Authorized Field Change

AFC G-08905

Subject: Instrument Cluster Connector Interference with the Defroster Duct on CE and BE Bus Models with MaxxForce 7 or MaxxForce DT Engines

Figure 5

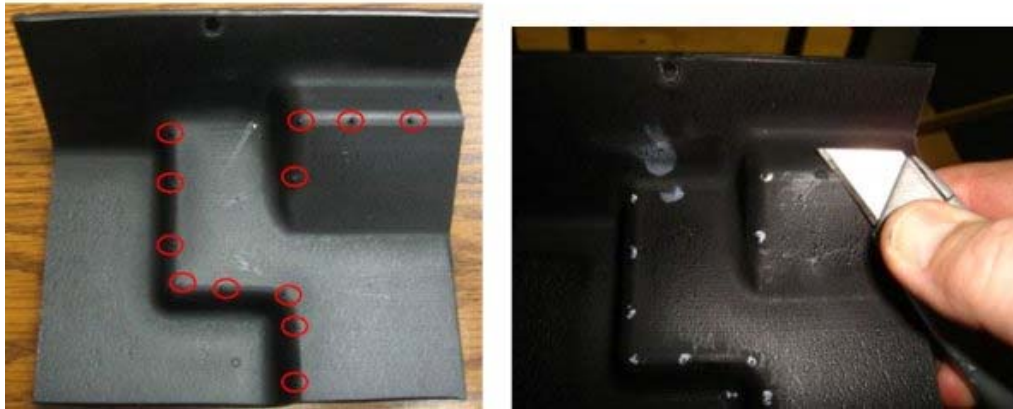
4. Remove the plastic nipples from the back side of the duct patch part with a utility knife. This will make the surface flush for a better fit (Figure 5).

Figure 6

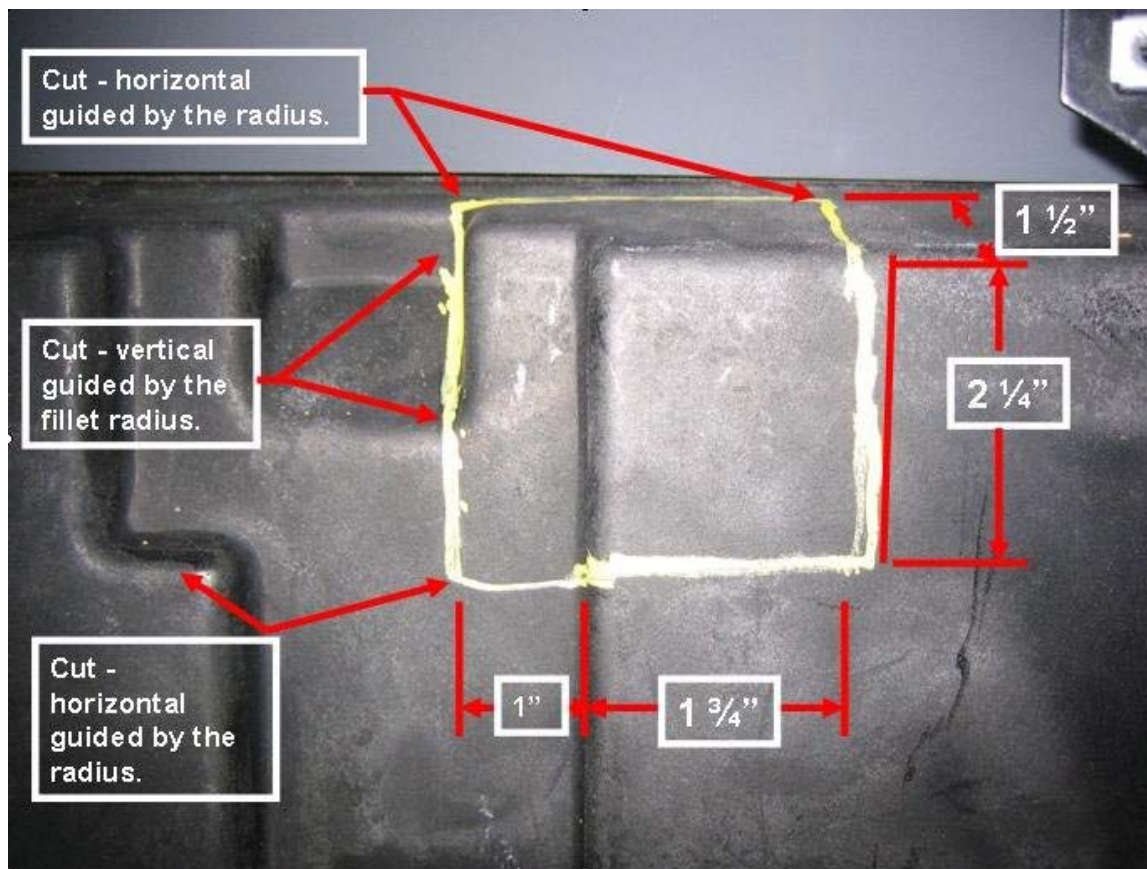
5. Measure and mark the defrost duct for the area that will be cut out (Figure 6).
